BULLETIN 31076

PJB ALTERNATOR EX LABEL

BULLETIN Alternator Compliance Decal

GE Industrea advises the following information relating to the GE00058M-X Flame Proof Alternator.

Label showing Certification number without X suffix.

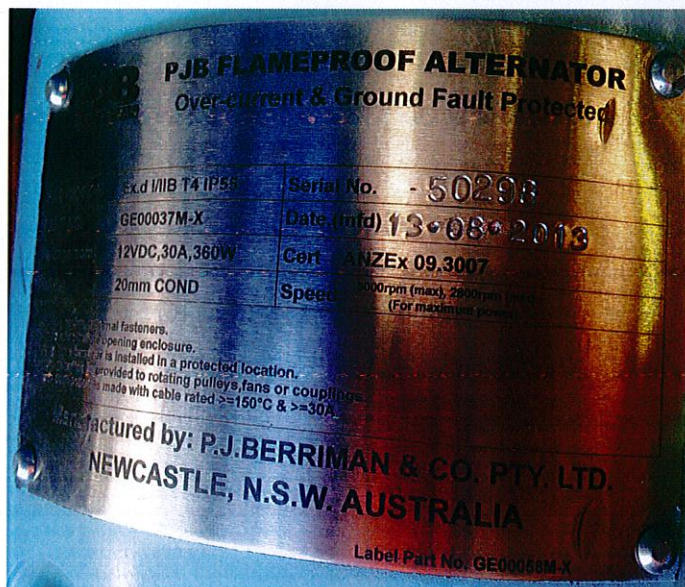
The Flame Proof Alternator GE00058M-X holding ANZEx 09.3007X certification has been released with incorrect labelling. The 'X' is missing from the compliance decal. The X indicates that specific **conditions of safe use** must be observed when the Alternator is installed.

GE Industrea recommends that all PJB Alternator labels be inspected at the next opportunity. Where the X is not included in the Certification number, an X should be stamped to permanently show the compliance requirement for *Conditions of Safe Use*. Each alternator application should review the installation and conditions of use to confirm compliance to the two conditions specified. Condition 1 – Installation Notes is attached for convenience.
